PLANNED UNIT DEVELOPMENT,
SUBDIVISION &
SIDEWALK WAIVER REQUEST
STAFF REPORT

Date: March 15, 2007

<u>NAME</u>	Mobile Area Water & Sewer System
<u>SUBDIVISION NAME</u>	MAWSS Eslava Creek Facilities Subdivision
<u>LOCATION</u>	1557 Sans Souci Road (South terminus of Sans Souci Road, extending South to I-10)
<u>CITY COUNCIL DISTRICT</u>	District 4
<u>PRESENT ZONING</u>	R-1, Single-Family Residential, and B-2, Neighborhood Business District
<u>AREA OF PROPERTY</u>	1 Lot / 16.6 \pm Acres
<u>CONTEMPLATED USE</u>	<i>Planned Unit Development</i> approval to allow multiple buildings on a single building site, including a severe weather attenuation tank, lift station, and auxiliary equipment to fill and withdraw wastewater from the tank, <i>Subdivision</i> approval to create one lot, and <i>Sidewalk Waiver</i> approval to waive construction of a sidewalk along Sans Souci Road.
<u>TIME SCHEDULE FOR DEVELOPMENT</u>	Immediate
<u>ENGINEERING COMMENTS</u>	The site can be checked against the National Wetlands Inventory on the COM web site Environmental Viewer. If the site is included on the NWI, it is the applicant's responsibility to confirm or deny the existence of regulatory wetlands. If wetl

SITE PLAN

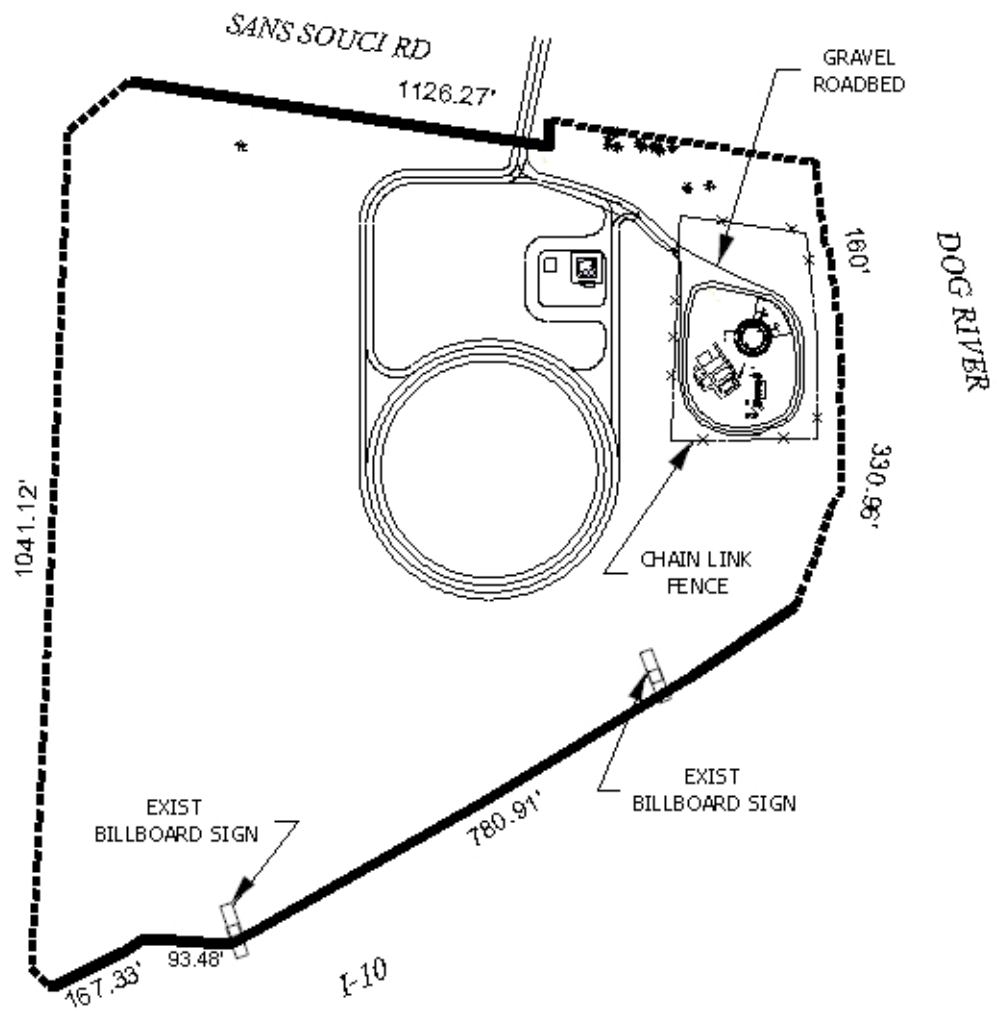
Access management for the site is a concern due to the presence of Interstate 10. A note should be placed on the Subdivision plat stating that access to the lot is limited to San Souci Road, with the size, design and location of the access to be approved by Traffic Engineering.

The minimum building setback line from all street frontages, required in Section V.D.9. of the Subdivision Regulations is not shown on the plat, but would be required on the final plat, if approved.

disturbance activities; 2) placement of a note on the plat stating that access to the lot is limited to Sans Souci Road, with the size, design and location of any access to be approved by Traffic Engineering and conform to AASHTO standards; 3) depiction of the 25-foot minimum building setback line on the site plan and plat; 4) labeling of the lot size in square feet; and 5) full compliance with all other municipal codes and ordinances.
